Ref: Application no: 10/707,919; Art Unit: 1744; Filing date: 01/26/2004

In response to your Office Action Summary received recently (June 2007), I make some corrections to my application as follows:

(54) METHOD AND APPARATUS FOR  
STERILIZING AIR IN LARGE VOLUMES BY  
RADIATION OF ULTRAVIOLET RAYS

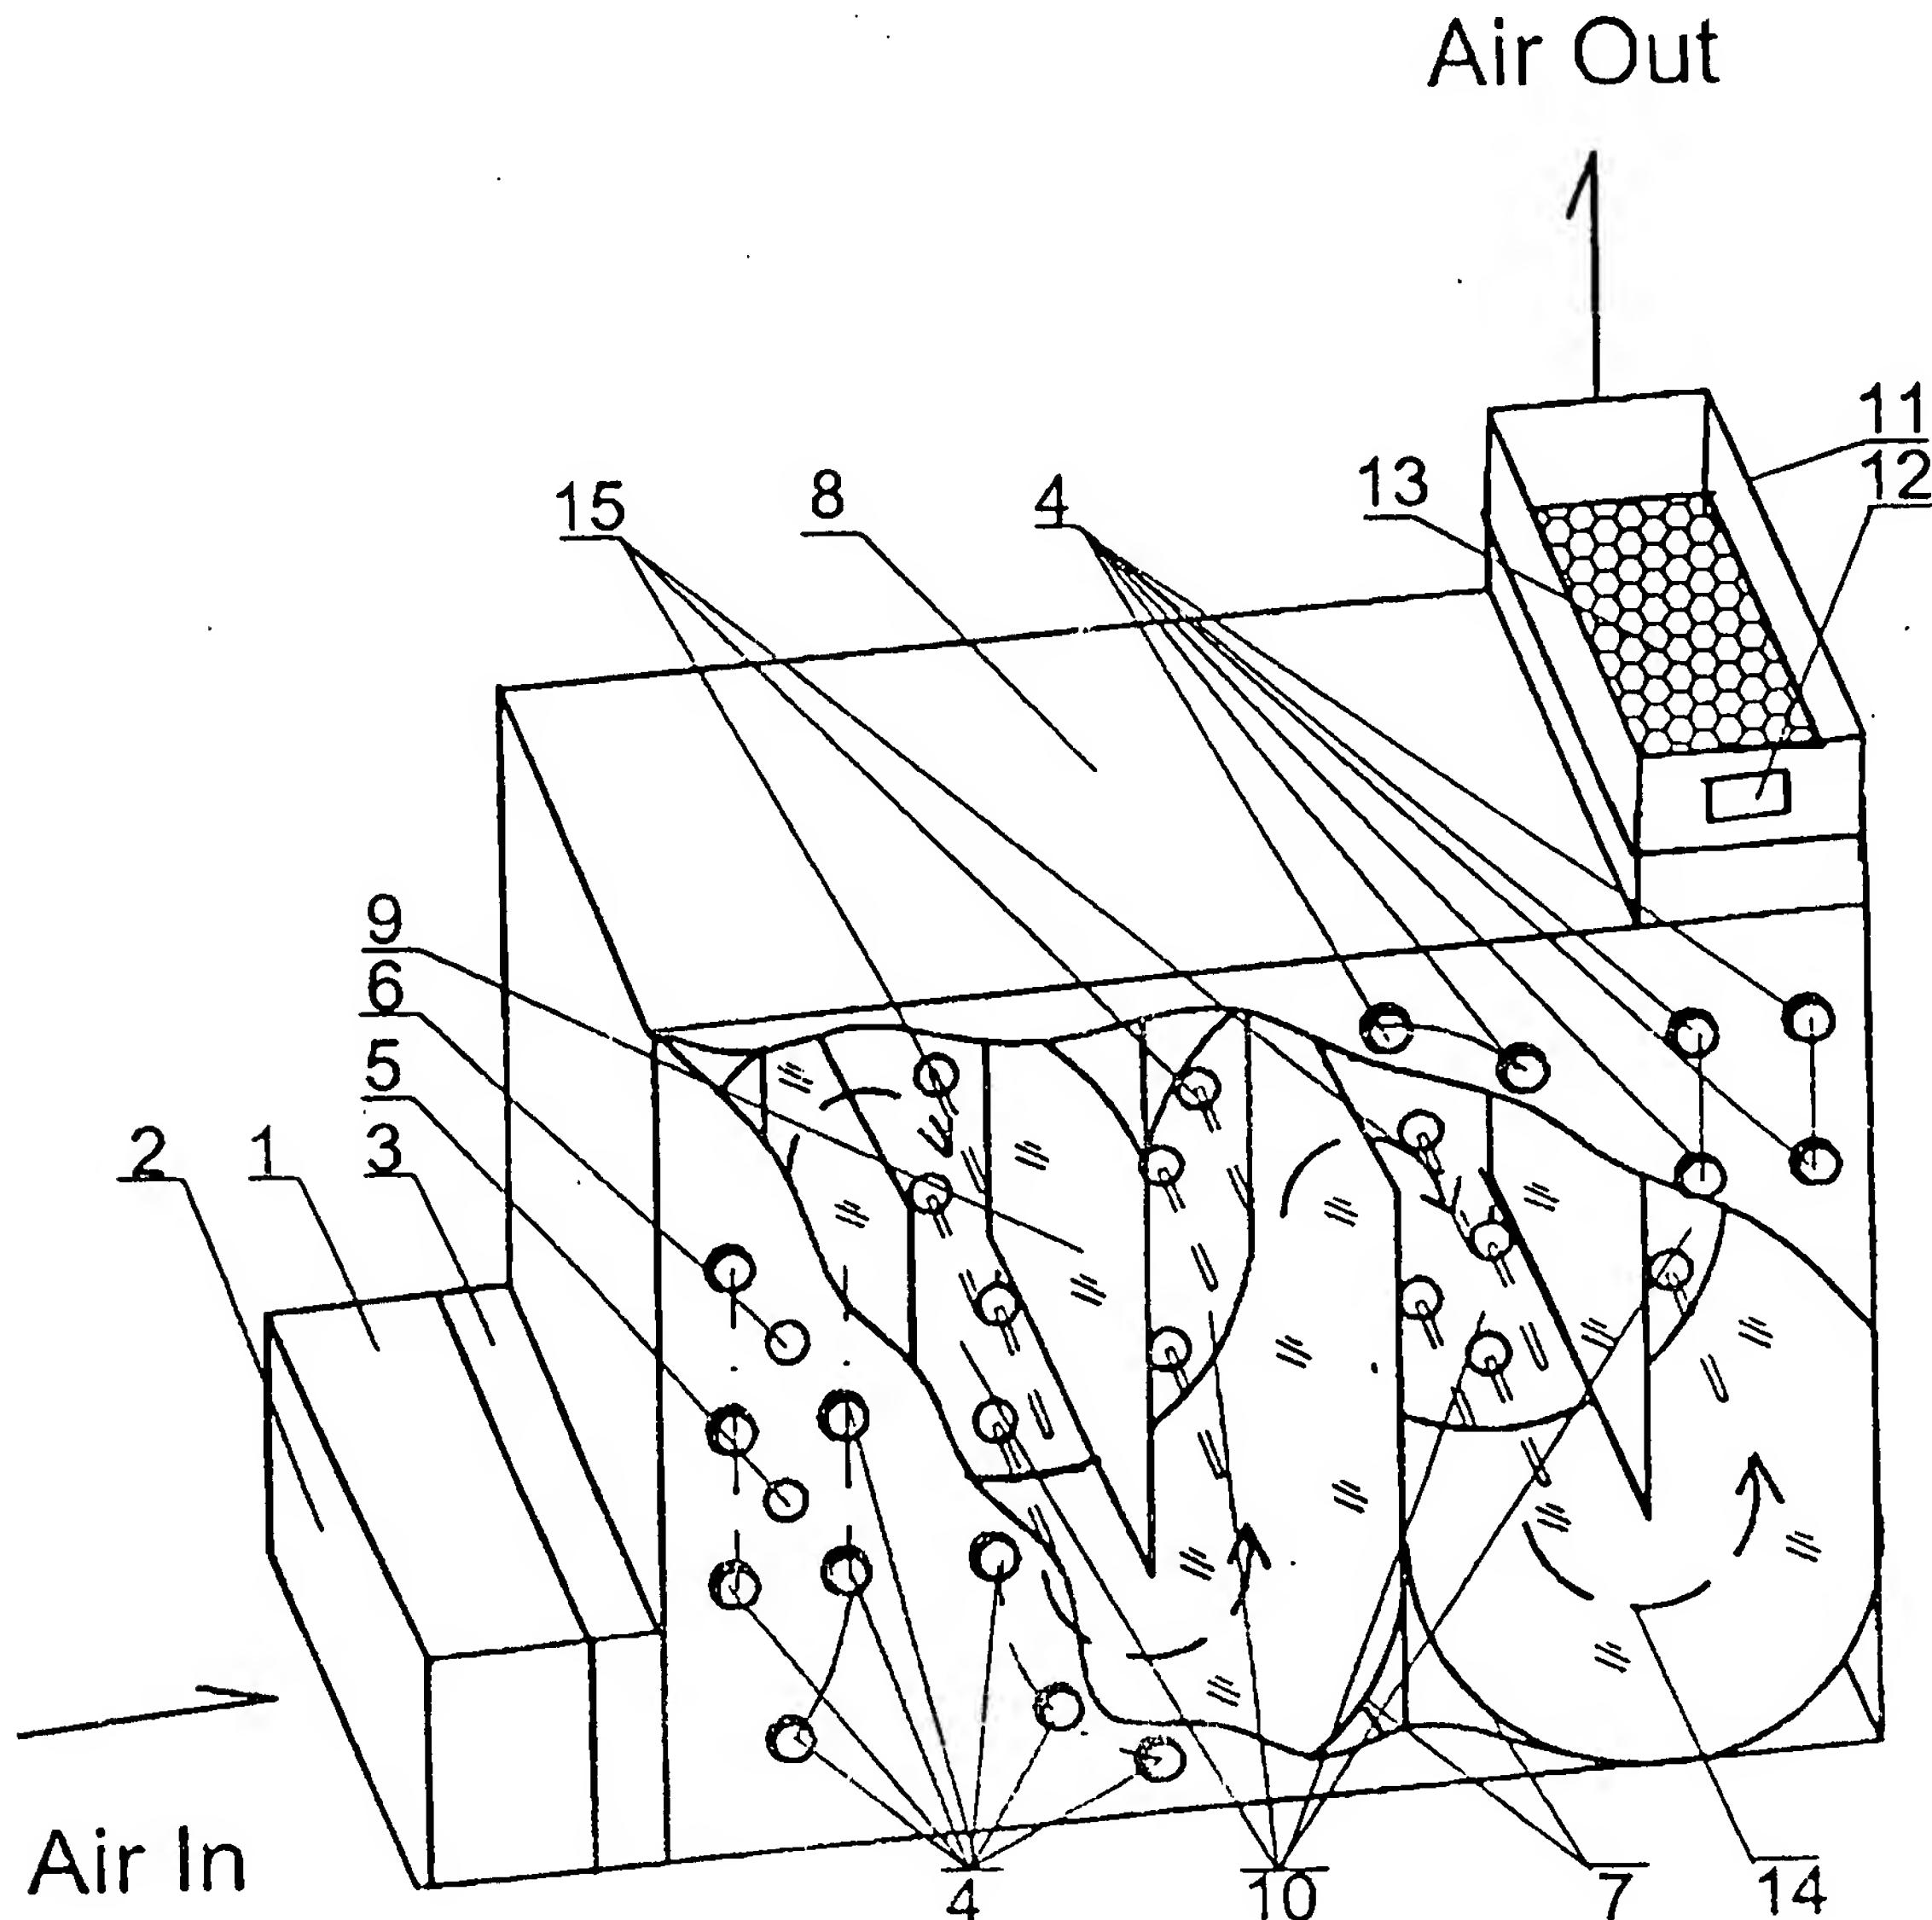
My invention employs chamber(s) interiorly partitioned into continually circuitous channel(s) by interior wall (my application figure 1 to 5:9) to contain the fluent material. The circuitous channel(s) in my method not only guarantee all fluent material will synchronously go through the sterilizing chamber with similar length, but also guarantees all fluent material equally exposed to designated amount of UV radiation.

Third, in my invention, the interior circuitous channel(s) of the chamber offers a flexible infrastructure for installing designated number of UV lamps. The length of the channel(s) and/or the number of roundabouts in the chamber can be changed to accomplish the sterilization target. In the preferred embodiment of my invention (figure 2), ninety-eight UV lamps are employed offering at least 1500W 253.7nm UV power to sterilizing air. However, Hiral’s method does not have such infrastructure and only employs one 254nm UV lamp.
